# MEMORANDUM

**Subject:** Item 1 – 8 Murrell Street, Macquarie Park (LDA2025/0068)

**Figure 1:** Indicative location of the existing pipelines referenced by recommended Condition 10A.

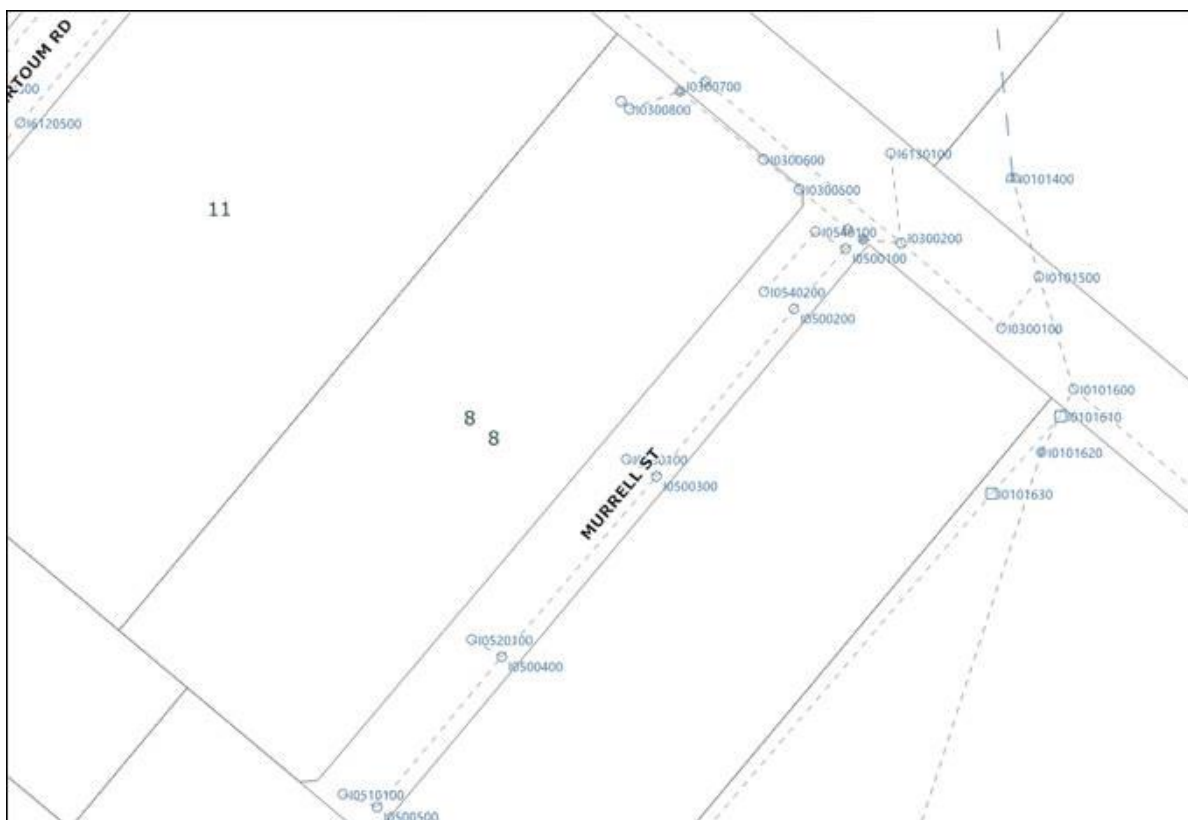
The applicant has questioned the location of the pipes referenced and submits that if the pipes are unlikely to be impacted, this part of the condition should be removed.

Council's Stormwater and Floodplain Management Engineer has advised that, as the exact location of the pipe to be constructed as part of the subject application is unknown, this condition should remain. Council's records provide a general indication of the location of the pipelines referenced by the condition, but not an exact location, as shown in Figure 1, below:

The Engineer has advised that it is the applicant's responsibility to identify the exact location of Council drainage assets using non-destructive methods. A minimum horizontal clearance of 1.0 metre must be maintained from the outermost edge of all Council stormwater pipes. For the Construction Certificate stage, Council requires updated plans showing the surveyed pipe location, including exact position, depth, invert level, and other relevant details.

Noting the above, it is not recommended that this condition be altered.
